STAFF REPORT
WEST ALLIS PLAN COMMISSION
Wednesday, July 23rd, 2025
6:00 PM

2. Site, Landscaping, and Architectural Design Review for F Street 92, LLC, a proposed 5+ Unit Dwelling use, at 1405 S. 92nd St. (Tax Key No. 450-0502-000)

DATE: 7/17/2025
TO: City of West Allis
CC: Ryan Neidinger – RINKA
PROJECT: 92nd and Greenfield Multifamily
PROJECT NO.: 24101
RE: Responses to City Staff Plan Commission Comments

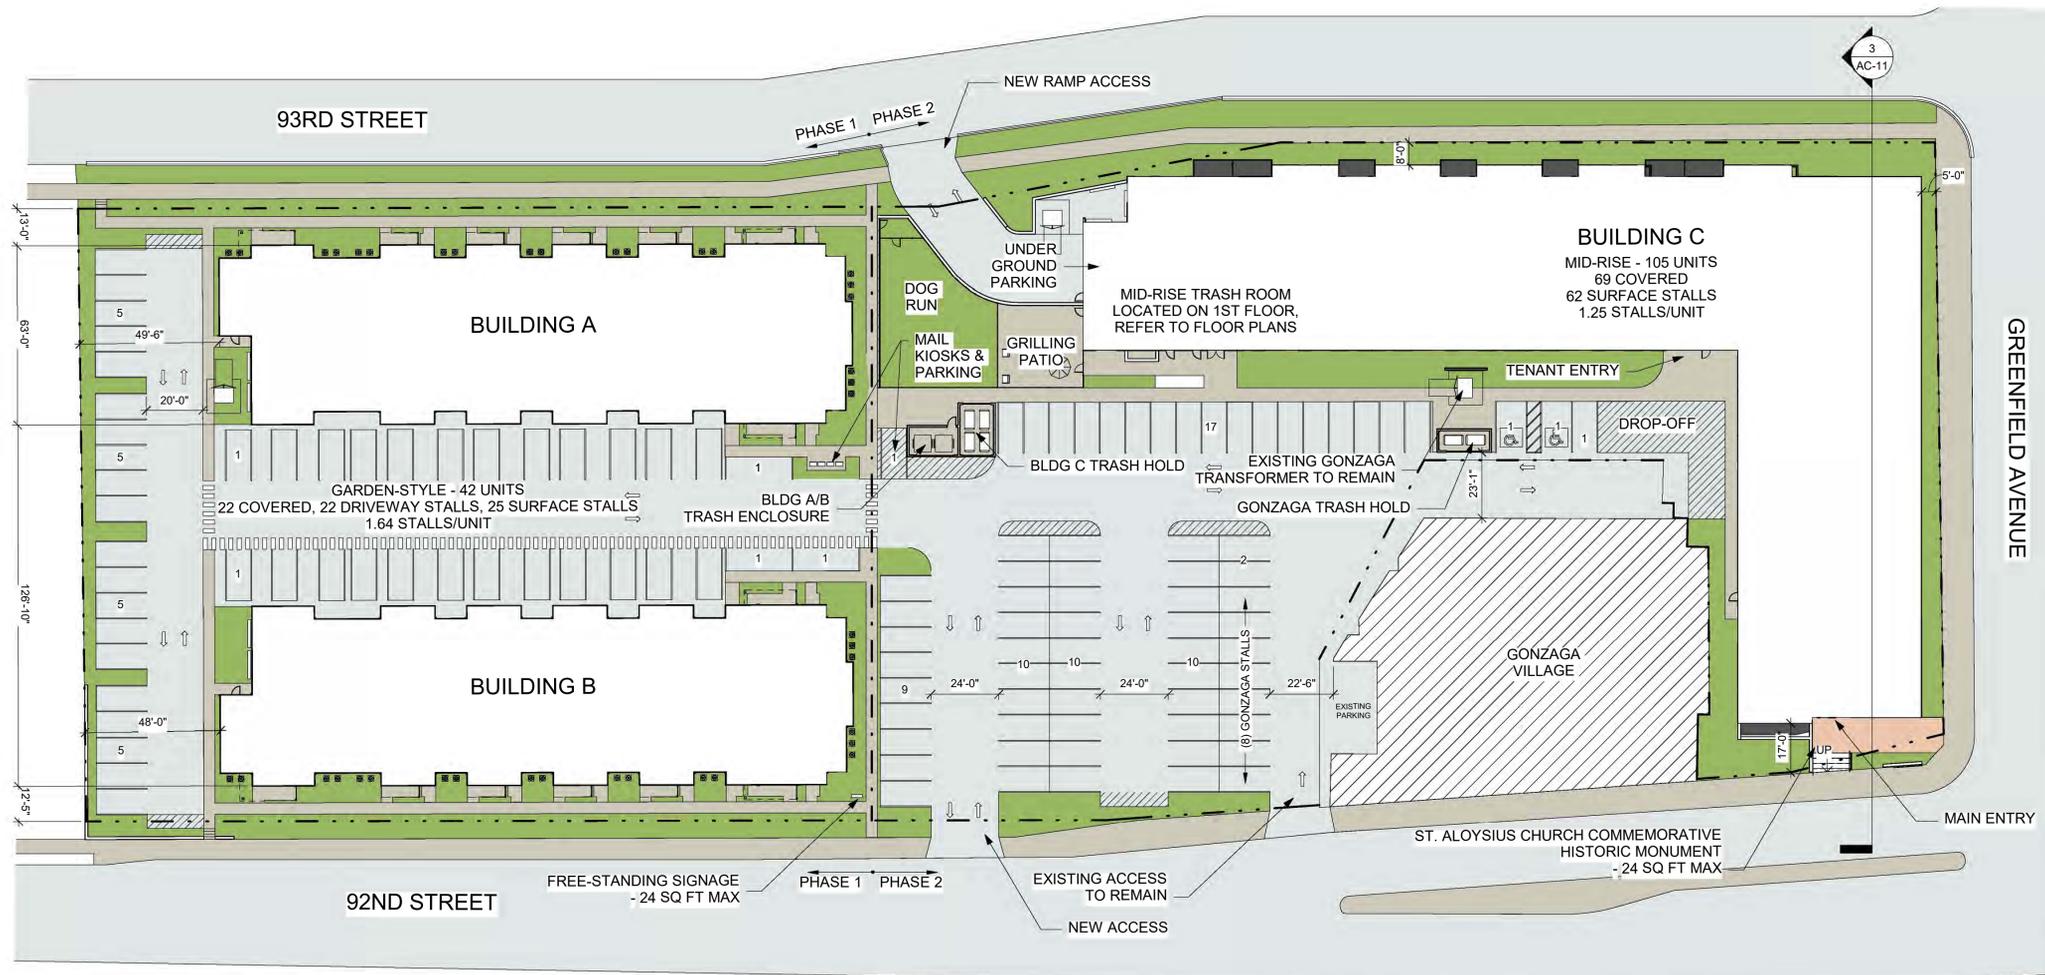
35. Add standpipes along roof or internally for additional fire house connections.

RINKA Response: Standpipe is anticipated.

1 ARCHITECTURAL SITE PLAN
 1" = 30'-0"

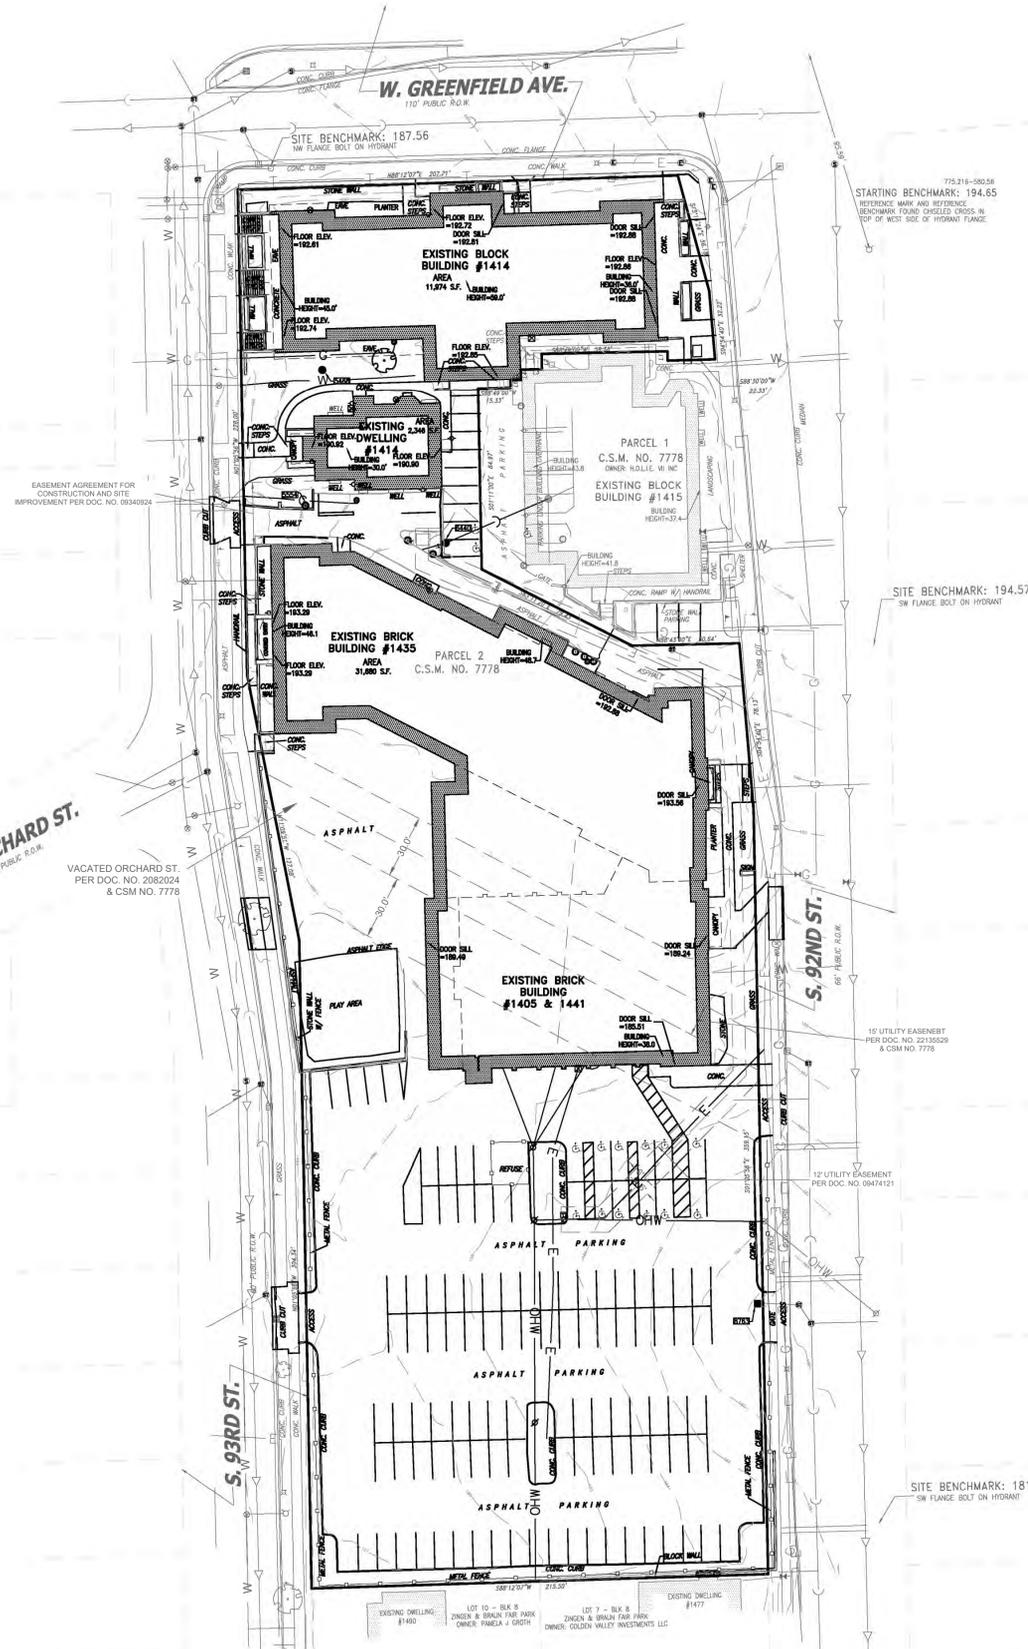
30. Please clarify driveway entrance directionals. Need confirmation of whether each driveway will be a right-in right-out or multi-directional.

RINKA Response: Refer to architectural site plan for intended directionals.

Sheet # **L-01**

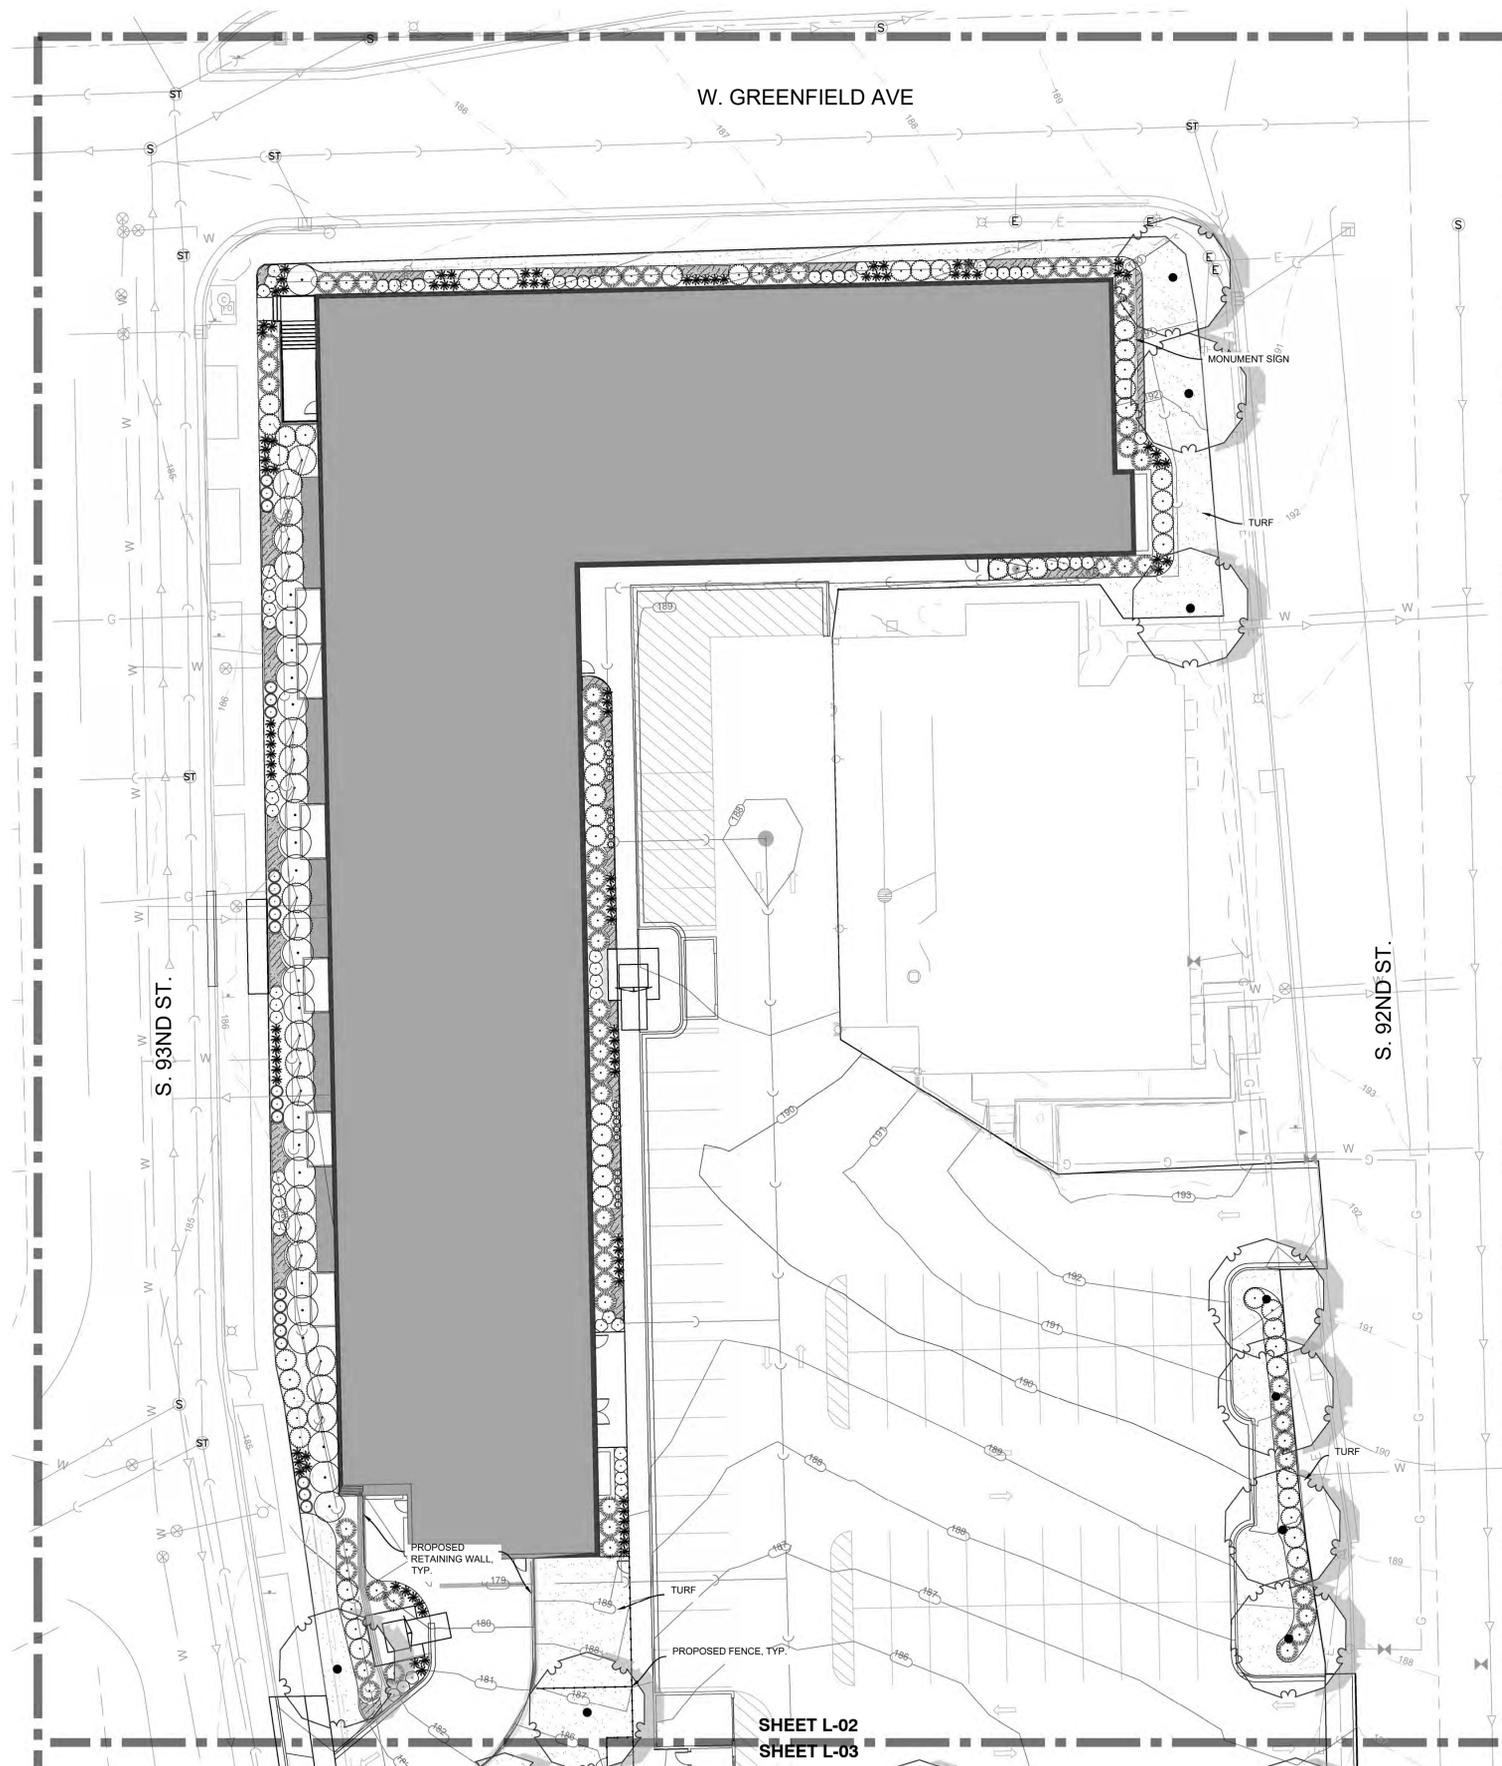
4. Will take a closer look at landscaping considerations on site. On the south end staff would recommend species to buffer parking from residences to the south.
RINKA Response: Refer to response #5.

5. South end of site - Existing currently is a chain link fence, perhaps a more decorative opaque fencing option could be utilized to provide more privacy. Ensure proposed landscaping will screen parking lot and lines of sight.

RINKA Response: A combination of screening landscape and/or 5' cedar fence is being considered along the southern property line.
